FACILITY COMPLIANCE AUDIT REPORT
Division of Waste Management
Solid Waste Section

Date of Audit: November 19, 2010 Date of Last Audit: March 9, 2005

Andrews Land Clearing and Inert Debris Landfill
 Doc Bennett Road
 Fayetteville, NC

Comprehensive Audit

Central area of LF, soil being removed.

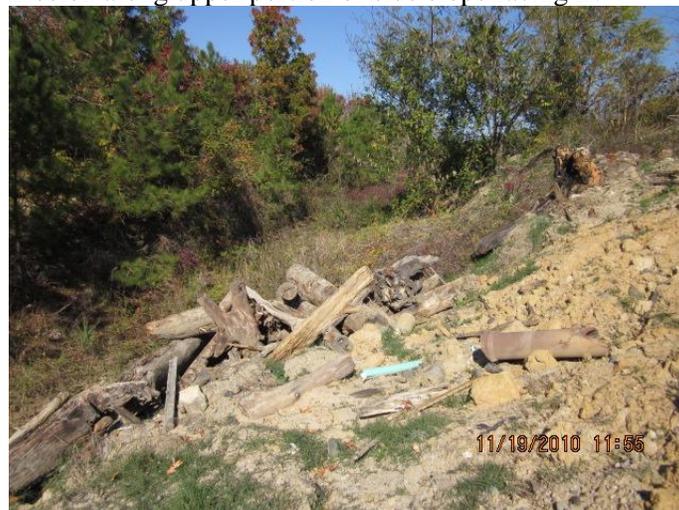
4. There were trees and thick vegetation growing on the western side of the landfill making it difficult to thoroughly inspect this area.
5. There was a denuded area near the center of the site where soil has been removed.

9. Uncovered, exposed waste must be covered and a vegetative cover established to prevent erosion.
10. Cease hauling waste to this site. Close the site in accordance with the Solid Waste Rules 15A NCAC 13B .0510 and 15A NCAC 13B .0566(5) or submit an application for a Land Clearing and Inert Debris landfill.
